**Source:** TSG CN WG 1  
**Title:** CR to R96 (with mirror CRs) on Work Item Multiband towards 04.08 and 24.008  
**Agenda item:** 7.12  
**Document for:** APPROVAL

This document contains 5 CRs, **R96 with mirror CRs to Work Item "Multiband"**, that have been agreed by **TSG CN WG1**, and are forwarded to TSG CN Plenary meeting #18 for approval.

<b>Title:</b>	⌘ Coding of the "Multiband Supported" bit field in the CM3 IE		
<b>Source:</b>	⌘ Siemens AG		
<b>Work item code:</b>	⌘ Multiband	<b>Date:</b>	⌘ 20.09.2002
<b>Category:</b>	⌘ <b>A</b>	<b>Release:</b>	⌘ R99
	<i>Use one of the following categories:</i> <b>F</b> (correction) <b>A</b> (corresponds to a correction in an earlier release) <b>B</b> (addition of feature), <b>C</b> (functional modification of feature) <b>D</b> (editorial modification) Detailed explanations of the above categories can be found in 3GPP <a href="#">TR 21.900</a> .		<i>Use one of the following releases:</i> <b>2</b> (GSM Phase 2) <b>R96</b> (Release 1996) <b>R97</b> (Release 1997) <b>R98</b> (Release 1998) <b>R99</b> (Release 1999) <b>Rel-4</b> (Release 4) <b>Rel-5</b> (Release 5) <b>Rel-6</b> (Release 6)

Figure 10.5.7/GSM 04.08: *Mobile Station Classmark 3* information element

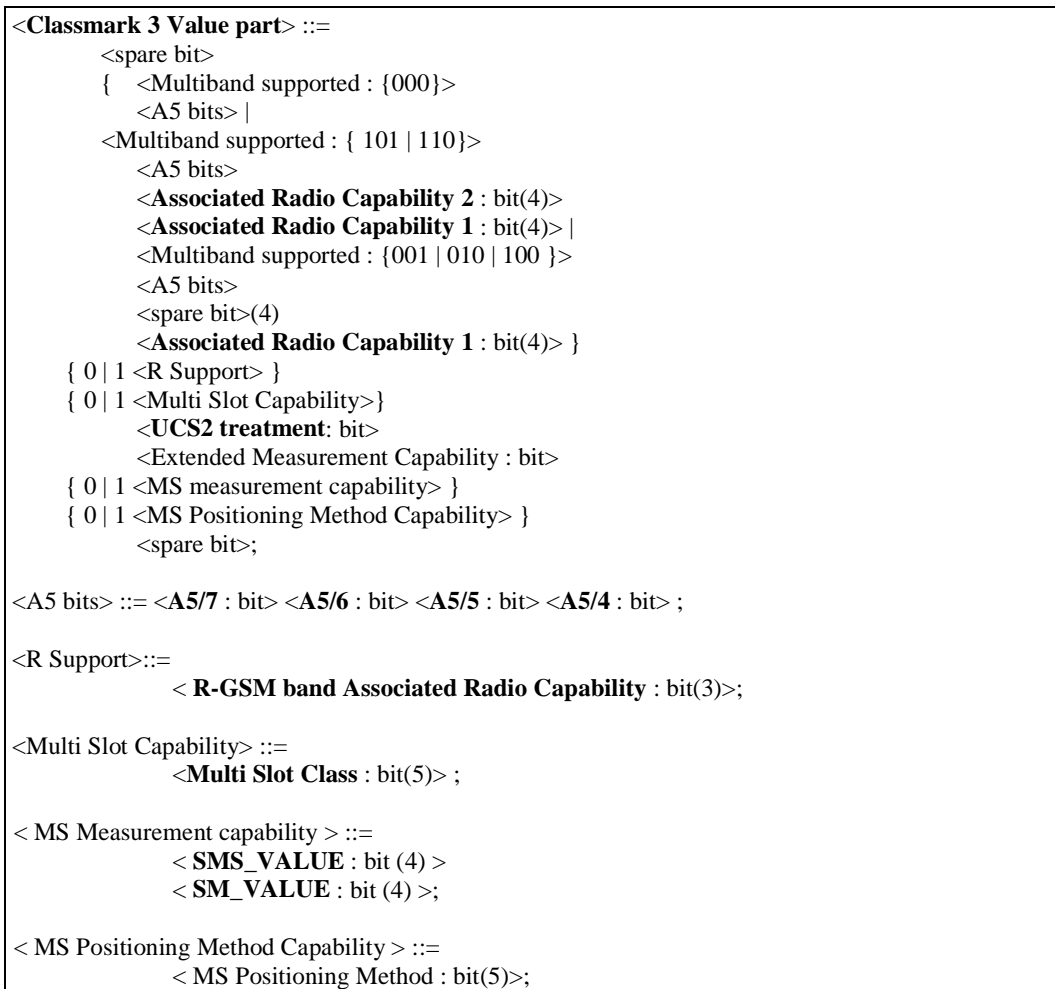
<b>Reason for change:</b>	⌘ When the IE description was transformed from table notation into CSN1 syntax the order of the bits of the " Multiband Supported" bit field has been reversed by error. In the CSN1 notation the left bit has the highest number, thus DCS 1800 which was bit 7 in table notation should be bit 3 in CSN1 and P-GSM which was bit 5 should be bit 1.
<b>Summary of change:</b>	⌘ The numbering of the Bit1-3 of the Multiband Supported bit field description is re-ordered in order to keep the order defined in the Phase2 specification.
<b>Consequences if not approved:</b>	⌘ Different bit position definitions for the Multiband Supported bit map between the phase 2 and R96 and onwards specifications, which would lead to interoperability problems if the MS and the network is assuming different meaning of the bits.

Multiband Supported (3 bit field)	
Band 1 supported ( <del>third bit of the field</del> )	
<u>Bit 1</u>	
0	P-GSM not supported
1	P-GSM supported
Band 2 supported ( <del>second bit of the field</del> )	
<u>Bit 2</u>	
0	E-GSM or R-GSM not supported
1	E-GSM or R-GSM supported
Band 3 supported ( <del>first bit of the field</del> )	
<u>Bit 3</u>	
0	DCS 1800 not supported
1	DCS 1800 supported
The indication of support of P-GSM band or E-GSM or R-GSM band is mutually exclusive.	
When the 'Band 2 supported' bit indicates support of E-GSM or R-GSM, the presence of the <R Support> field, see below, indicates if the E-GSM or R-GSM band is supported.	
In this version of the protocol, the sender indicates in this field either none or two of these 3 bands supported. However, if only one band is indicated, the receiver shall ignore the Associated Radio Capability 2.	
For single band mobile station all bits are set to 0.

Figure 10.5.7/GSM 04.08: *Mobile Station Classmark 3* information element

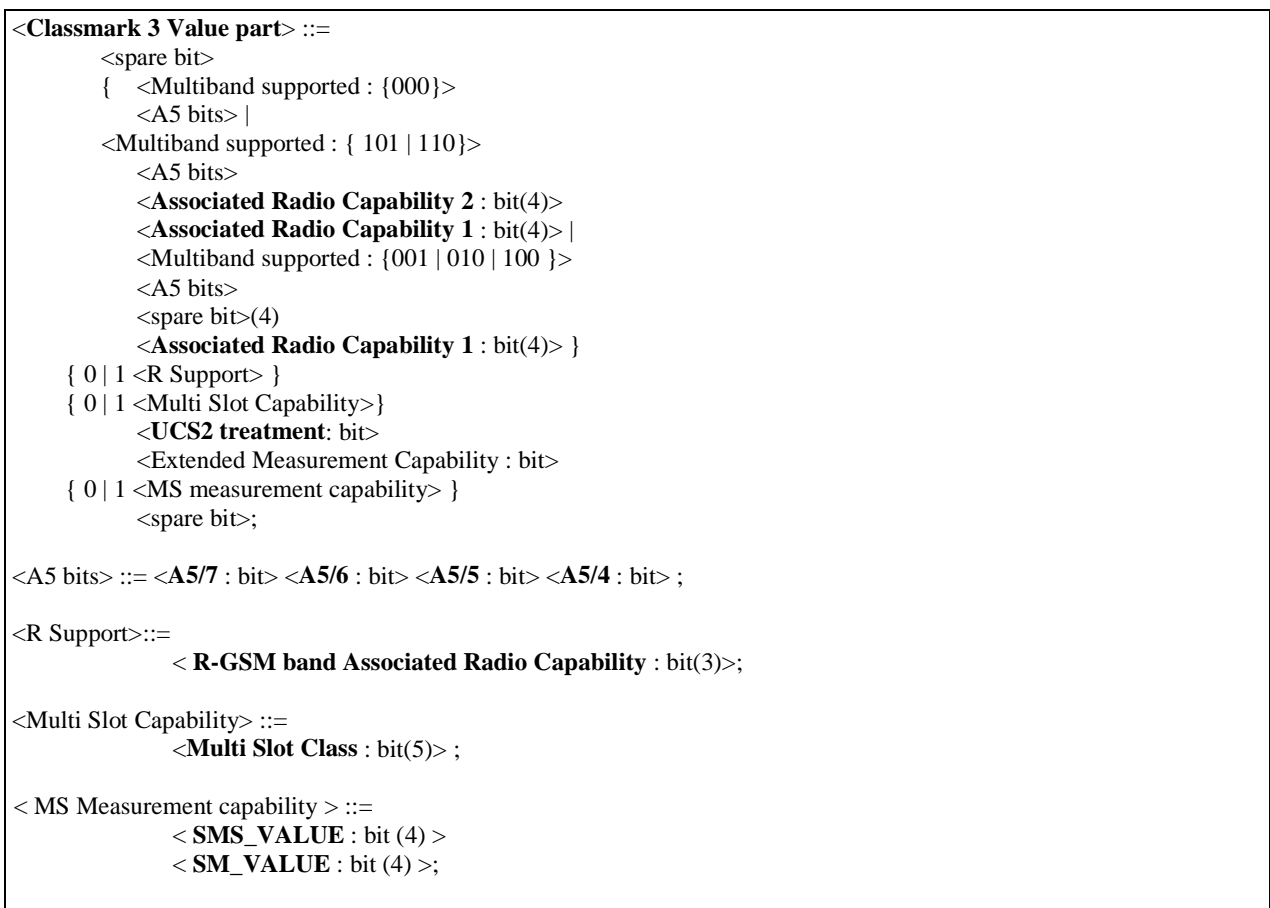
<b>Reason for change:</b>	⌘ When the IE description was transformed from table notation into CSN1 syntax the order of the bits of the " Multiband Supported" bit field has been reversed by error. In the CSN1 notation the left bit has the highest number, thus DCS 1800 which was bit 7 in table notation should be bit 3 in CSN1 and P-GSM which was bit 5 should be bit 1.
<b>Summary of change:</b>	⌘ The numbering of the Bit1-3 of the Multiband Supported bit field description is re-ordered in order to keep the order defined in the Phase2 specification.
<b>Consequences if not approved:</b>	⌘ Different bit position definitions for the Multiband Supported bit map between the phase 2 and R96 and onwards specifications, which would lead to interoperability problems if the MS and the network is assuming different meaning of the bits.

Multiband Supported (3 bit field)	
Band 1 supported ( <del>third bit of the field</del> )	
<u>Bit 1</u>	
0	P-GSM not supported
1	P-GSM supported
Band 2 supported ( <del>second bit of the field</del> )	
<u>Bit 2</u>	
0	E-GSM or R-GSM not supported
1	E-GSM or R-GSM supported
Band 3 supported ( <del>first bit of the field</del> )	
<u>Bit 3</u>	
0	DCS 1800 not supported
1	DCS 1800 supported
The indication of support of P-GSM band or E-GSM or R-GSM band is mutually exclusive.	
When the 'Band 2 supported' bit indicates support of E-GSM or R-GSM, the presence of the <R Support> field, see below, indicates if the E-GSM or R-GSM band is supported.	
In this version of the protocol, the sender indicates in this field either none or two of these 3 bands supported. However, if only one band is indicated, the receiver shall ignore the Associated Radio Capability 2.	
For single band mobile station all bits are set to 0.

Figure 10.8/GSM 04.08: *Mobile Station Classmark 3* information element

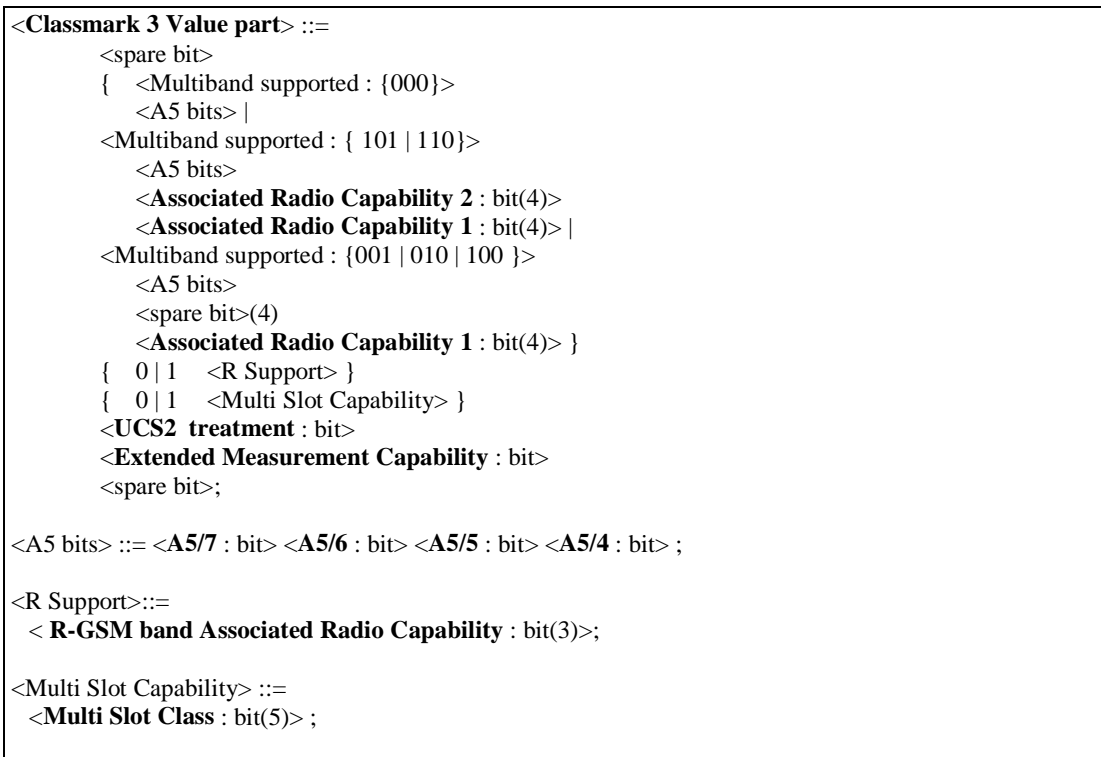
<b>Reason for change:</b>	⌘ When the IE description was transformed from table notation into CSN1 syntax the order of the bits of the " Multiband Supported" bit field has been reversed by error. In the CSN1 notation the left bit has the highest number, thus DCS 1800 which was bit 7 in table notation should be bit 3 in CSN1 and P-GSM which was bit 5 should be bit 1.
<b>Summary of change:</b>	⌘ The numbering of the Bit1-3 of the Multiband Supported bit field description is re-ordered in order to keep the order defined in the Phase2 specification.
<b>Consequences if not approved:</b>	⌘ Different bit position definitions for the Multiband Supported bit map between the phase 2 and R96 and onwards specifications, which would lead to interoperability problems if the MS and the network is assuming different meaning of the bits.

<p><b>Multiband Supported</b> (3 bit field)</p> <p>Band 1 supported (<del>third bit of the field</del>)</p> <p><u>Bit 1</u></p> <p>0 P-GSM not supported 1 P-GSM supported</p> <p>Band 2 supported (<del>second bit of the field</del>)</p> <p><u>Bit 2</u></p> <p>0 E-GSM or R-GSM not supported 1 E-GSM or R-GSM supported</p> <p>Band 3 supported (<del>first bit of the field</del>)</p> <p><u>Bit 3</u></p> <p>0 DCS 1800 not supported 1 DCS 1800 supported</p> <p>The indication of support of P-GSM band or E-GSM or R-GSM band is mutually exclusive.</p> <p>When the 'Band 2 supported' bit indicates support of E-GSM or R-GSM, the presence of the &lt;R Support&gt; field, see below, indicates if the E-GSM or R-GSM band is supported.</p> <p>In this version of the protocol, the sender indicates in this field either none or two of these 3 bands supported. However, if only one band is indicated, the receiver shall ignore the Associated Radio Capability 2.</p> <p>For single band mobile station all bits are set to 0.</p> <p><b>A5/4</b></p> <p>0 encryption algorithm A5/4 not available 1 encryption algorithm A5/4 available</p> <p><b>A5/5</b></p> <p>0 encryption algorithm A5/5 not available 1 encryption algorithm A5/5 available</p> <p><b>A5/6</b></p> <p>0 encryption algorithm A5/6 not available 1 encryption algorithm A5/6 available</p> <p><b>A5/7</b></p> <p>0 encryption algorithm A5/7 not available 1 encryption algorithm A5/7 available</p> <p><b>Associated Radio capability 1 and 2</b></p> <p>If either of P-GSM or E-GSM or R-GSM is supported, the radio capability 1 field indicates the radio capability for P-GSM, E-GSM or R-GSM, and the radio capability 2 field indicates the radio capability for DCS1800 if supported, and is spare otherwise.</p> <p>If none of P-GSM or E-GSM or R-GSM are supported, the radio capability 1 field indicates the radio capability for DCS1800, and the radio capability 2 field is spare.</p> <p>The radio capability contains the binary coding of the power class associated with the band indicated in multiband support bits (see GSM05.05).</p> <p><b>R Support</b></p> <p>In case where the R-GSM band is supported the R-GSM band associated radio capability field contains the binary coding of the power class associated(see GSM 05.05) A mobile station supporting the R-GSM band shall also when appropriate, see 10.5.1.6, indicate its support in the 'FC' bit in the Mobile Station Classmark 2 information element.</p> <p>Note: the coding of the power class for P-GSM, E-GSM, R-GSM and DCS 1800 in radio capability 1 and/or 2 is different to that used in the Mobile Station Classmark 1 and Mobile Station Classmark 2 information elements.</p> <p><b>Multi Slot Class</b> (5 bit field)</p> <p>In case the MS supports the use of multiple timeslots then the Multi Slot Class field is coded as the binary representation of the multislot class defined in TS GSM 05.02.</p> <p><b>UCS2 treatment</b></p> <p>This information field indicates the likely treatment by the mobile station of UCS2 encoded character strings. If not included, the value 0 shall be assumed by the receiver.</p> <p>0 the ME has a preference for the default alphabet (defined in GSM 03.38) over UCS2.</p>
